Special Use Permit (SUP) Application Report

RE: Administrative Approval (COA-137360-2023) for 3820 Hermitage Road– New Garage material specifications

Site Plan
 3820 Hermitage Road - Detached Garage Plans
 Manuchehr and Rebecca A Amirsoleimani
 City of Richmond, VA

Building Permit - Approved Construction Documents
Under general authority of the Building Code, this approved set of construction documents shall be kept on the job site at all times and shall not be altered without approval from the Building Official. This permit does not approve any Electrical, Mechanical or Plumbing work. This approval does not relieve the builder from complying with manufacturer instructions, Virginia Uniform Statewide Building Code and City of Richmond regulations whether noted, implied or omitted. Approved Plans: 20231117_3320 Hermitage Rd. BLDR-126560-2023 12/13/2023 11:20:35 AM

Site Plan
1/16" = 1'-0"

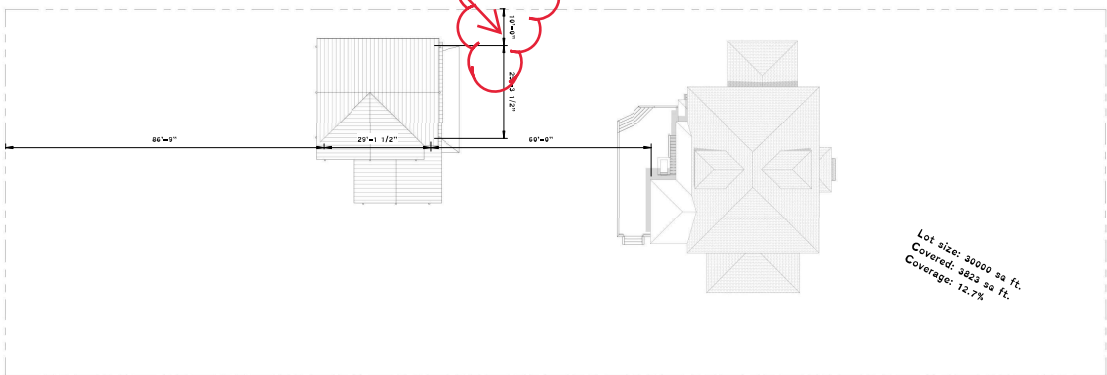
Request 5' from
Property Line

Sections

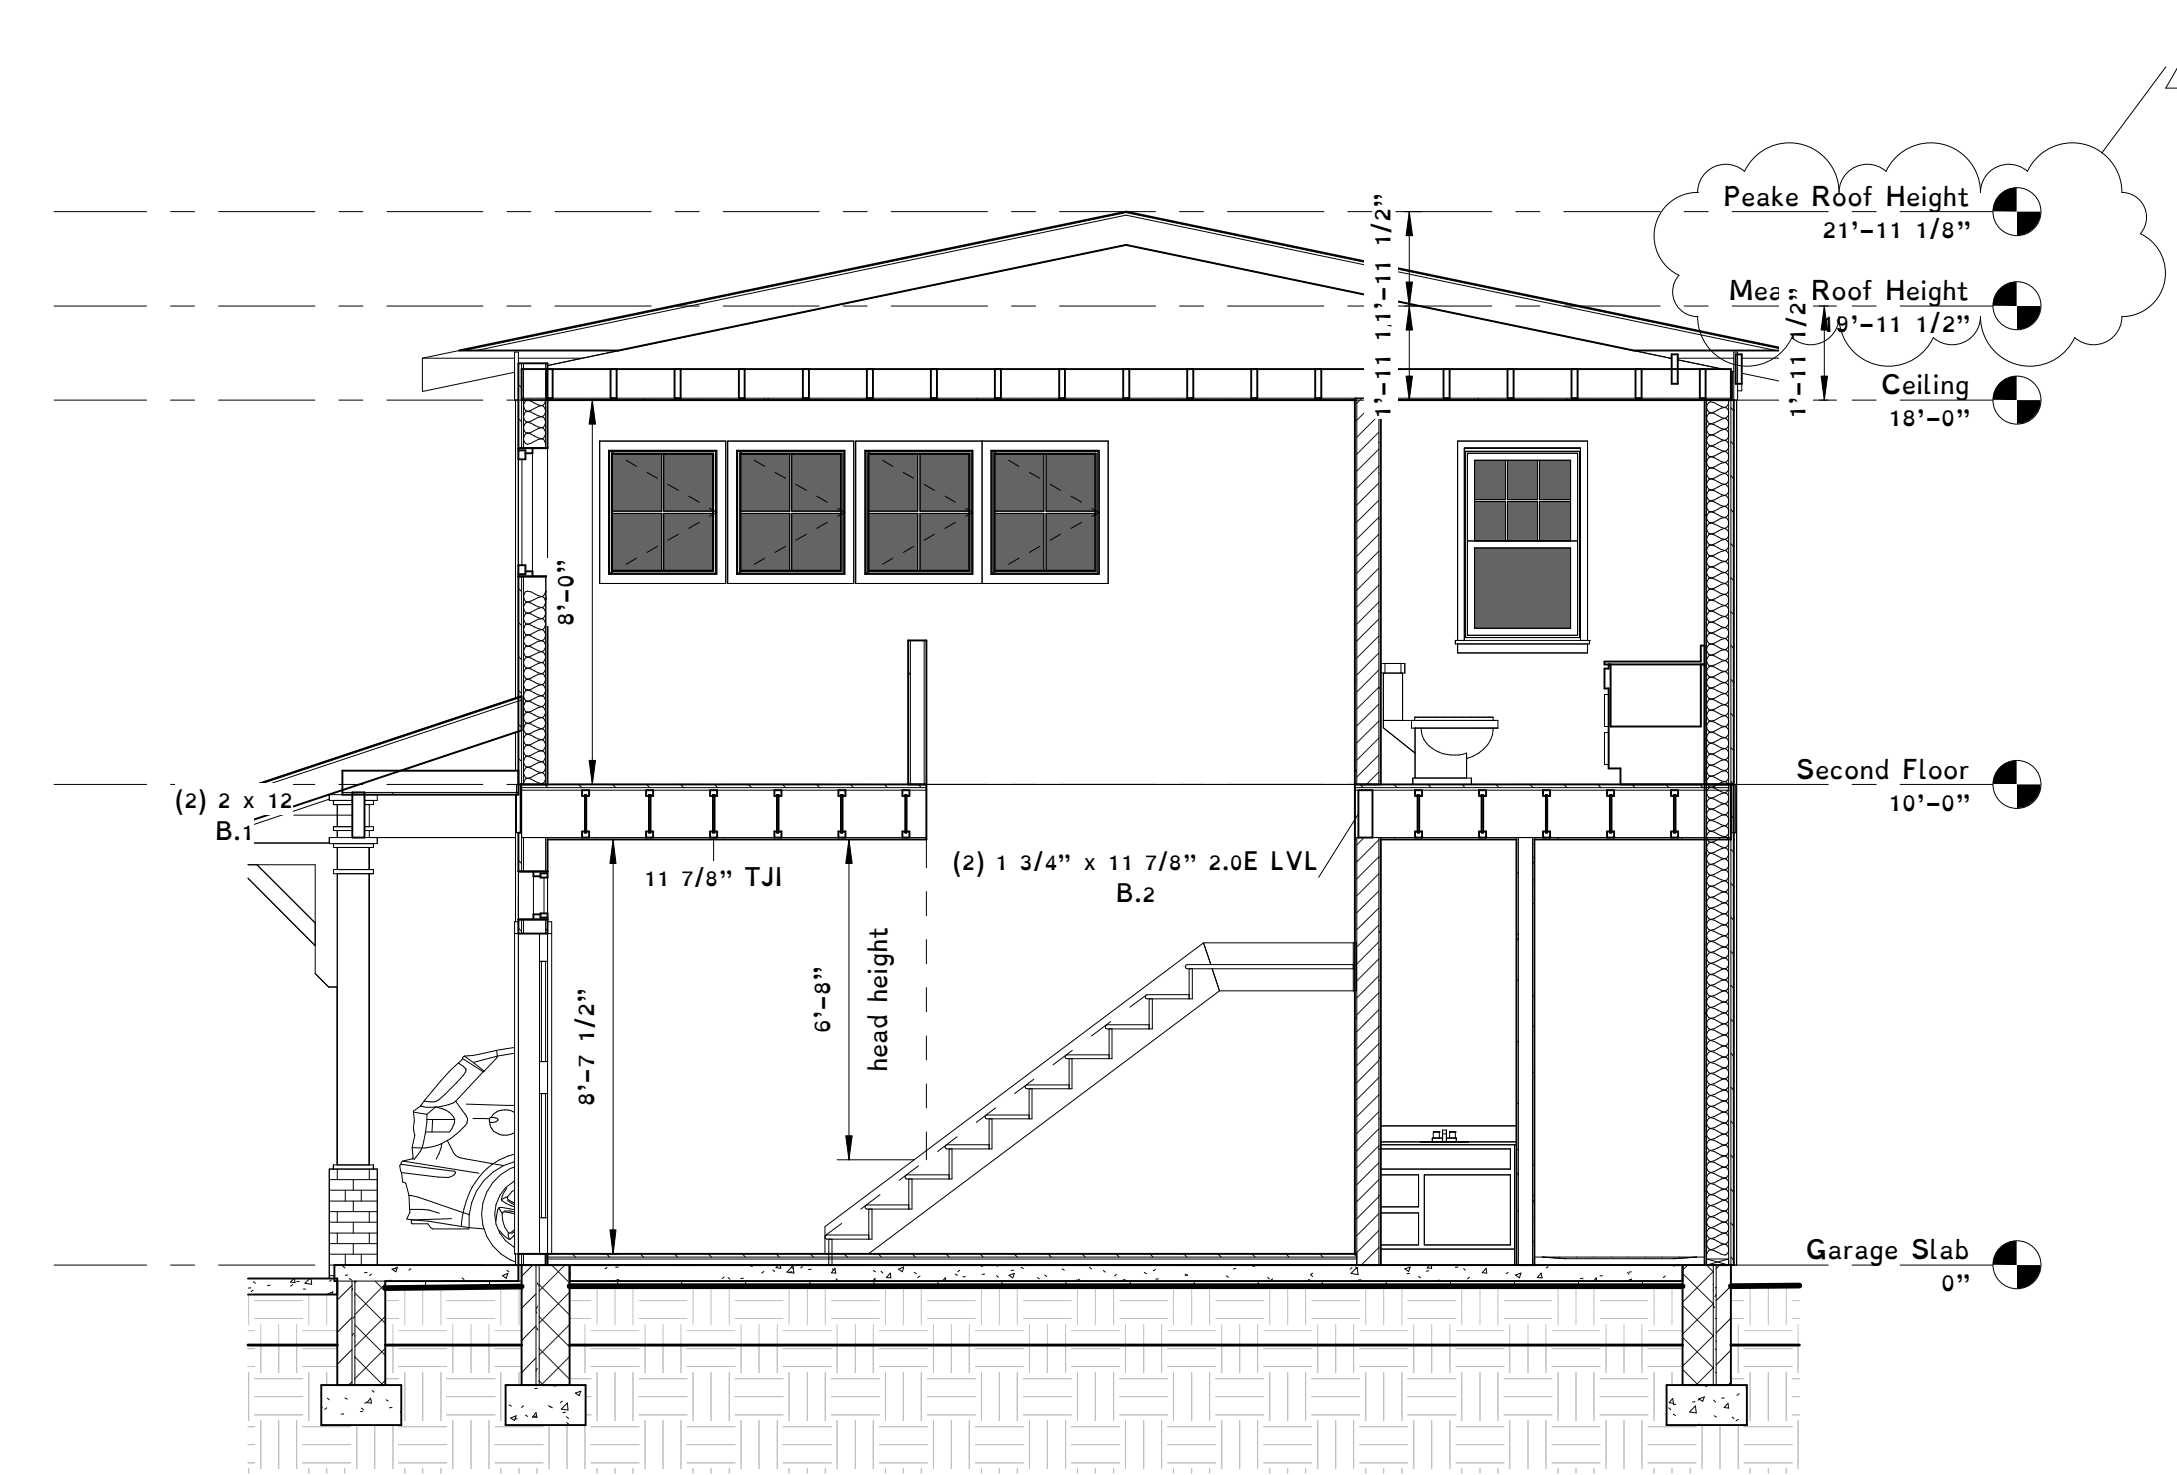
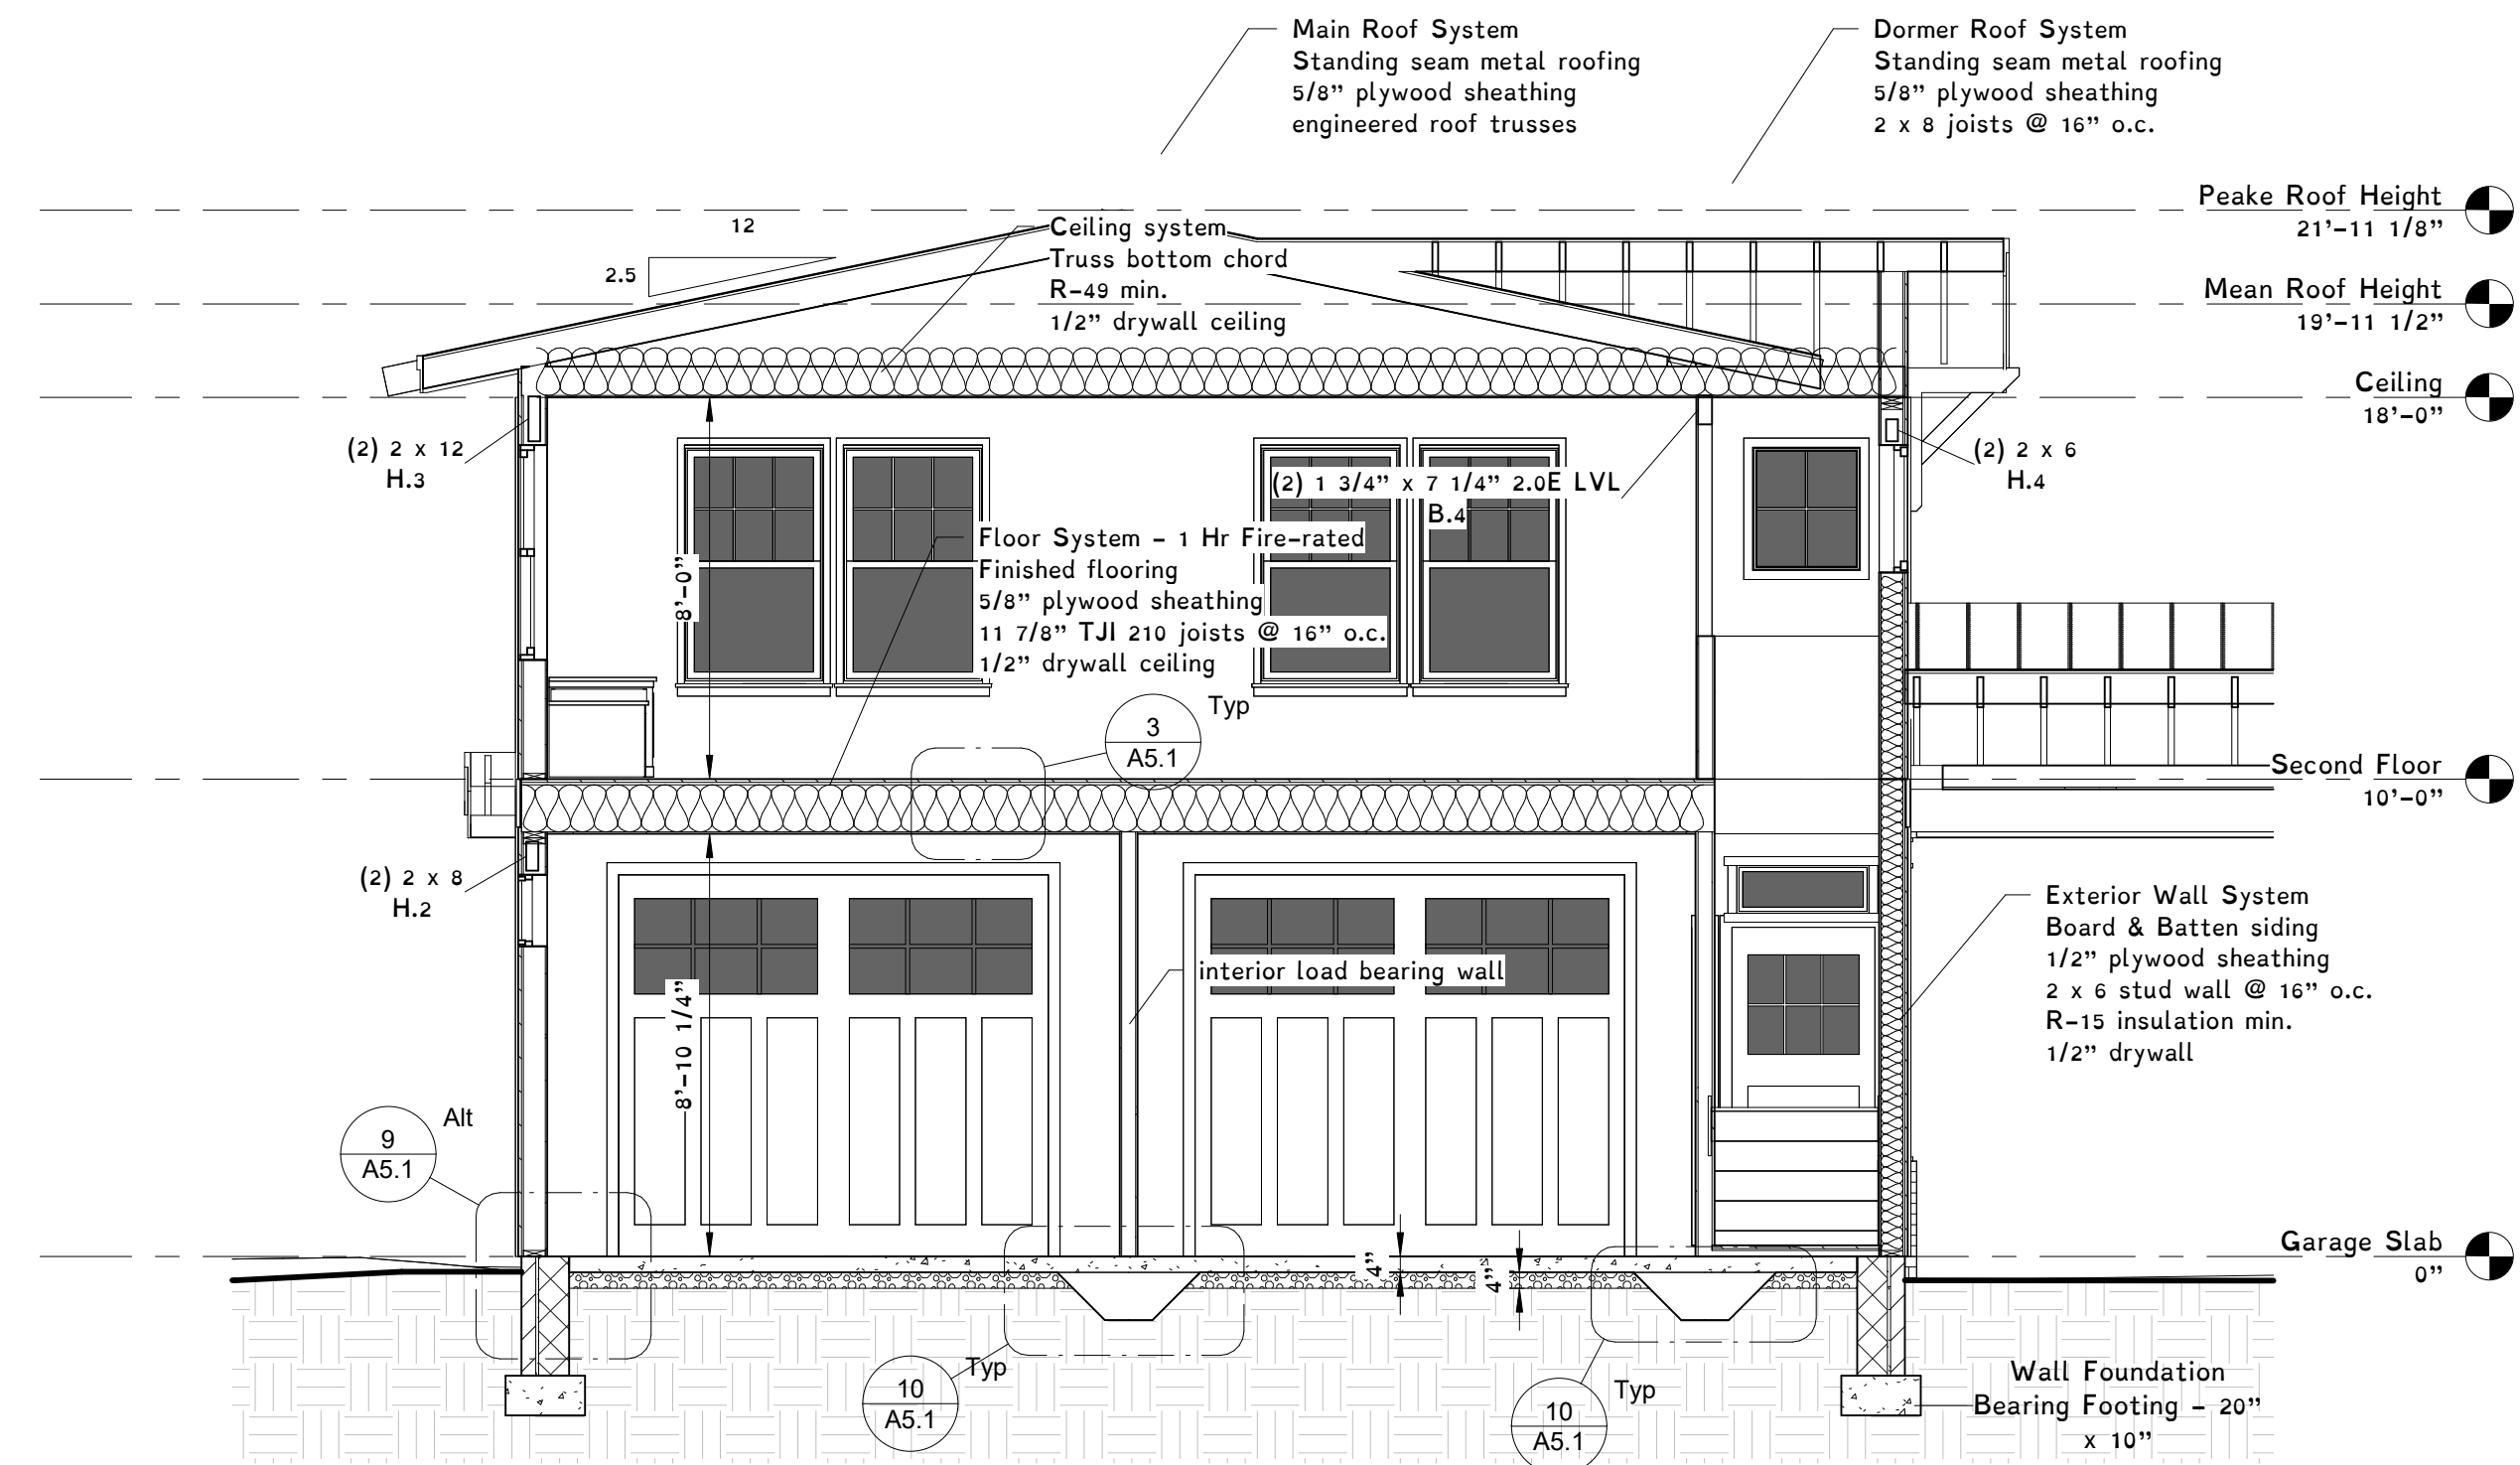
Per Section and Table R302.6 in the 2018 Virginia Residential Code the garage must be separated from habitable rooms above with not less than 5/8" Type X gypsum board or equivalent.

Per Section R403.1.4.1 in the 2018 Virginia Residential Code, except where otherwise protected from frost, foundation walls, piers, and other permanent supports of buildings and structures shall be protected from frost. This can be accomplished by extending the footing below the frost line (18" in the City of Richmond).
